## *Memorandum*

SUBJECT: **RETAIL BUILDING WITH MAJOR WARRANTS (MW2018-01)**

**SITE PLAN**  
**LOT 8C, BLOCK A**  
**THE VILLAGE AT FAIRVIEW ADDITION**

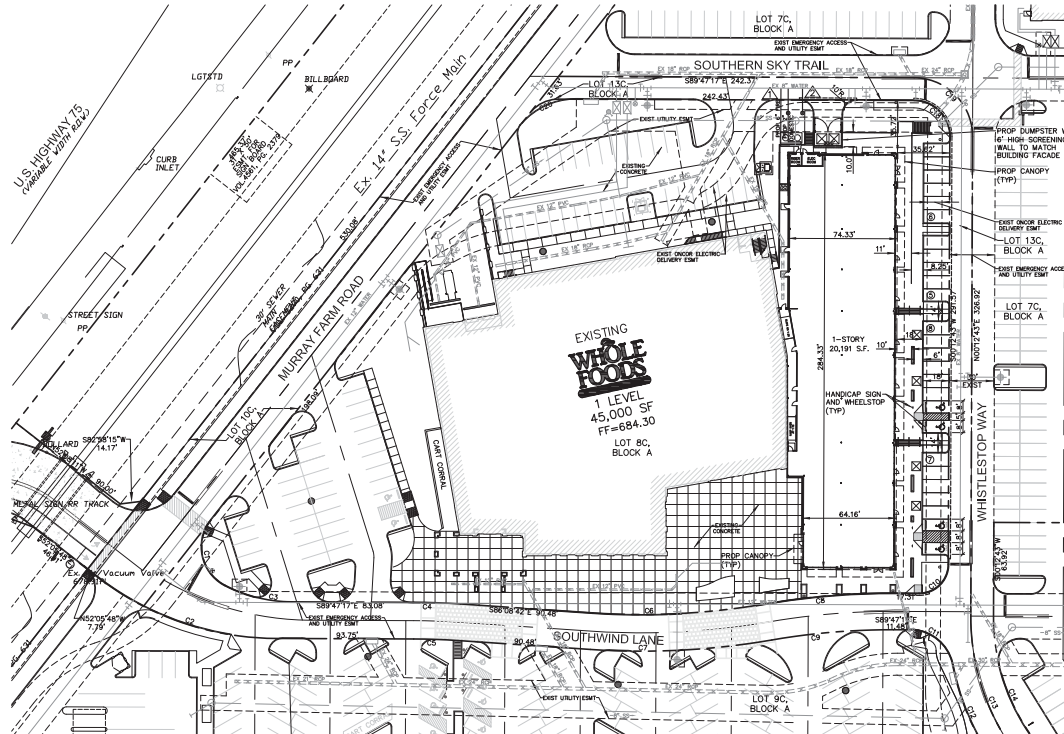
Item	Requirements	Proposed	Applicant Justification	Staff Comments
1	Site, Block and Building Type standards (Sec. 3.6 & 3.7)	BTZ 18'-26' with 80% frontage	As shown: 36' setback along Whistlestop Way; 38' along Southern Sky Trail, no frontage	Conflict with existing easements and development patterns established under different CPDD regulations. Proposed design with head-in parking is similar to existing parking lot while providing for some tree locations.	Since the entirety of the Fairview Town Center was developed under a different version of the CPDD, the design standards for access, building form, placement, and design were different than what the current CPDD code requires. In this case, the applicant has made great effort to try and design this project within the parameters of the new code, while accommodating many existing non-conforming features.
		50' ROW with street trees and parallel parking	30' access easement (existing) with head-in parking and recessed trees with grates where possible

2	Window Percentage (Sec. 3.7.6.c.2.iv)	60%-80%	North Elev: 48%	The north elevation is adjacent to the dumpster area and is the location of various interior utilities and service areas, where windows are unnecessary	The north elevation is the service and utility portion of the building that is adjacent to the loading dock of Whole Foods. Awnings and windows have been provided in the public portion of the façade.
			East Elev: 85%	5% increase is reflective of interior design	This small increase is reflective of the interior design and the required façade rhythm in the new version of the CPDD code.

**RECOMMENDATION:** Staff recommends **APPROVAL** of the subject major warrants and the preliminary plat subject to the following conditions:

1. Site shall be development generally in accordance with the attached development plan exhibits.
